RE: Underground Injection Control (UIC)
Minor Permit Modifications
WPX Pennington SWD #1 (ND22335-10898)

Modification Number Minor Modification #1 Well Name Pennington UIC Permit Number ND22335-10898

Revised Appendix A Well Schematic - Minor modification March, 2018

WPX Energy
Pennington SWD #1
Section 2 - T150N - R92W
Montrail County, North Dakota

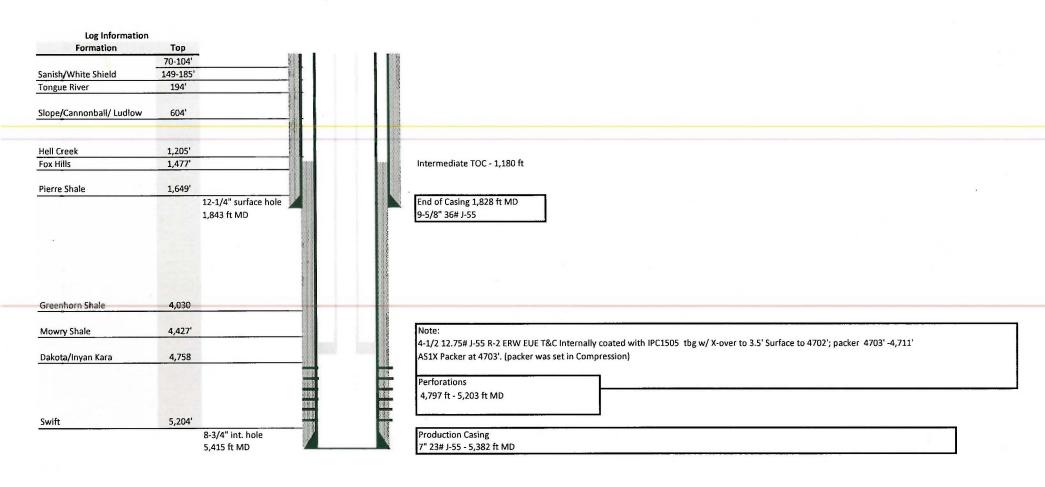
The Environmental Protection Agency Region 8 (EPA) has received WPX's February 2, 2018 email requesting changing the tubing size from 3.5" to 4.5" (Revised Appendix A schematic enclosed), performing an acidization job in the injection zone to improve injectivity (Procedure enclosed), and performing a step rate test (SRT) after the tubing change to determine the new maximum allowable injection pressure (MAIP). Once the tubing change has been done, a mechanical integrity test (MIT) shall be performed to ensure the well's integrity. Once the EPA has reviewed and approved the MIT in writing, the well may continue to operate at a maximum injection rate of 415 barrels per hour (bbl/hr). Based on the results of the SRT, the Permittee may request a new MAIP in a separate modification request. The SRT will be performed using both surface and bottom hole (bomb) pressure gauges. If parting pressure is not achieved during the SRT, the maximum pressure achieved during the test will be the new MAIP, even if it is below the formation parting pressure.
